**METROPOLITAN GOVERNMENT OF NASHVILLE AND DAVIDSON COUNTY**

**STAFF RECOMMENDATION**  
**919 Petway Avenue**  
**November 20, 2013**

**Application:** New Construction--Infill  
**District:** Greenwood Neighborhood Conservation Zoning Overlay  
**Council District:** 06  
**Map and Parcel Number:** 08204038900  
**Applicant:** Brandon Jaynes, Kudzu Real Estate  
**Project Lead:** Sean Alexander, sean.alexander@nashville.gov

**Description of Project:** Application is to construct infill on a site that currently contains a non-contributing structure. The structure will be one and one-half story tall, with a form similar to that of a historic Craftsman style bungalow. The exterior materials of the structure will include: cement-fiber clapboard siding, fiberglass shingle roof, and a parged-coated foundation.

sheet no.  
**A2**

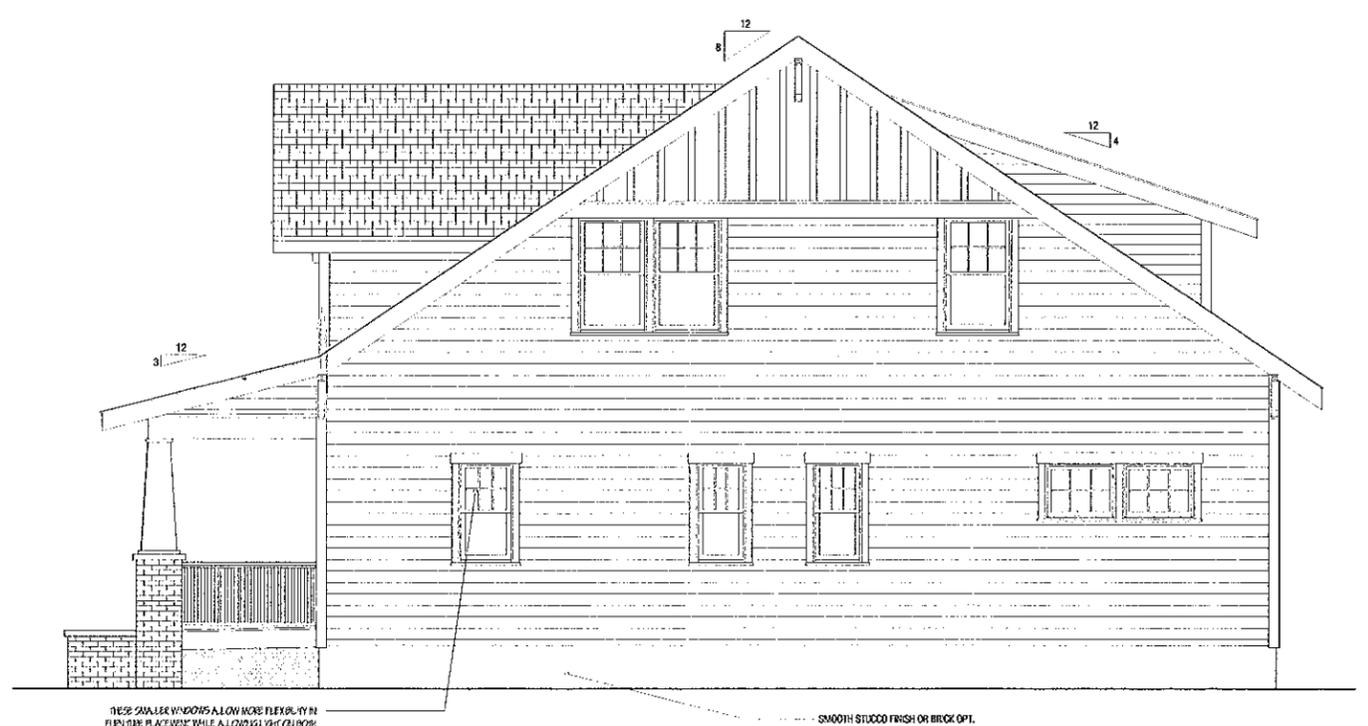
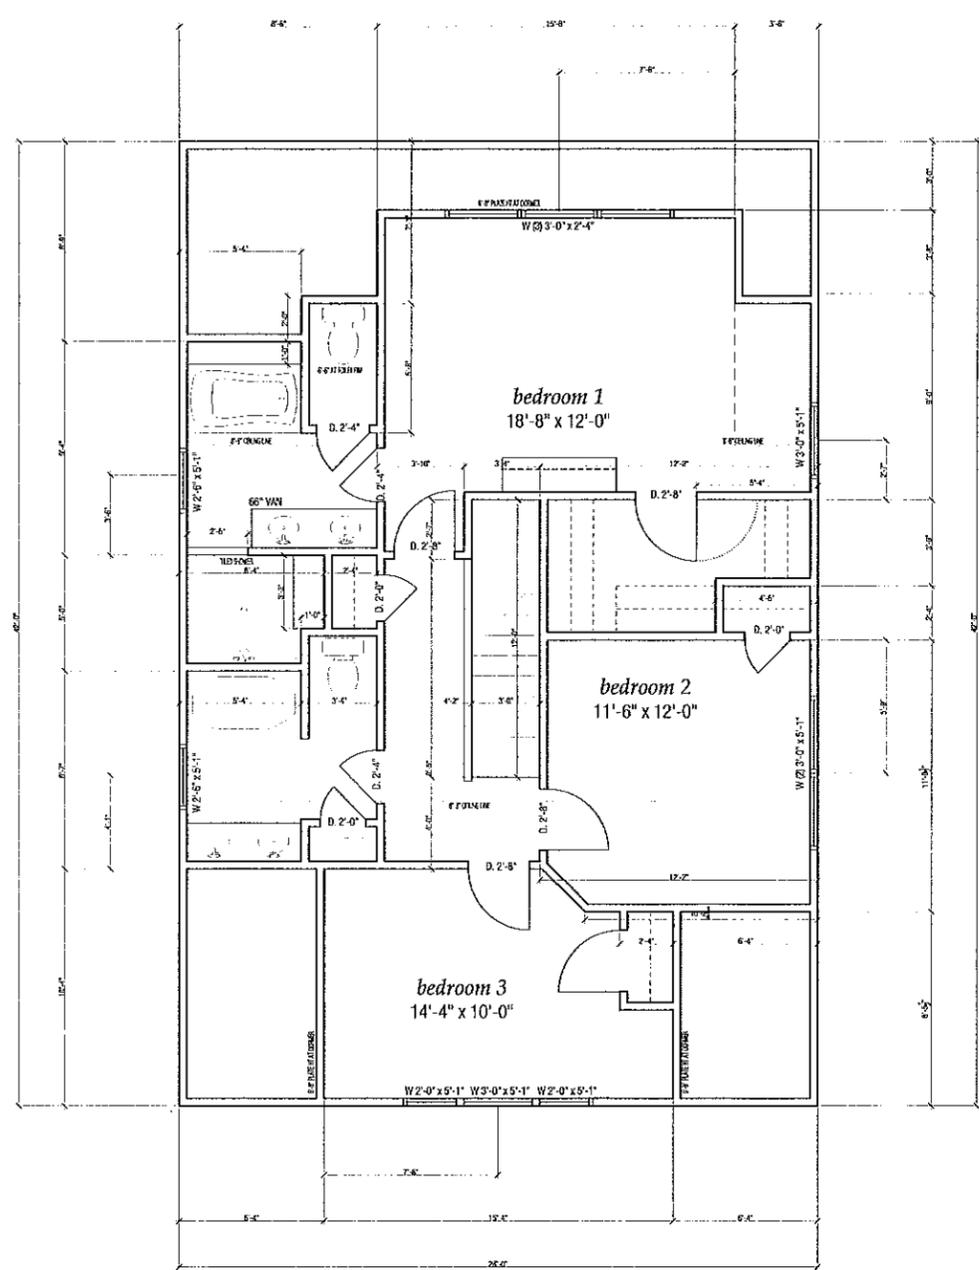
The house will be thirty-two feet (32') wide across the front elevation, with an eight foot (8') deep full width projecting porch. The proportions and form are similar to those of a Craftsman style bungalow, which is a common historic house in the area. On the front of the house there will be a gabled dormer in the upperstory, with the front wall stacking directly above the first story wall. Dormers on this type of house, side gabled with a projecting porch, would typically be set back two feet (2') from the wall below.

Additionally, Staff finds that the front porch column bases are atypical in that they continue beyond the porch floor all the way to grade. Staff recommends that the column bases end at the porch floor level instead of continuing down to grade.

With a condition that the dormer is moved back two feet (2') from the first story wall and the porch columns not extend below the porch floor, Staff finds that the project will meet guideline II.B.1.a.and b.

The windows on the proposed new house are all generally twice as tall as they are wide on the front elevation, and there are no large expanses of wall space without a window or door opening. The proportions of windows on the side elevation are less compatible in their proportions and placement. Historically windows on a multi-story house were either the same height or taller on the first floor where the building was more likely to have taller ceilings than in the upper stories; therefore, taller windows on an upper-story are inappropriate for the historic context. With a condition that the proportions of windows be more compatible with those on surrounding historic houses, staff finds the project's proportion and rhythm of openings would meet Section II.B.1.g.

- A walkway be included from the porch to the public sidewalk;
- The front porch column bases not extend below the floor level of the front porch;
- Staff approve all windows and doors and the brick or sample for the front porch columns prior to purchase and installation;
- The upperstory windows are no taller than those on the first story;
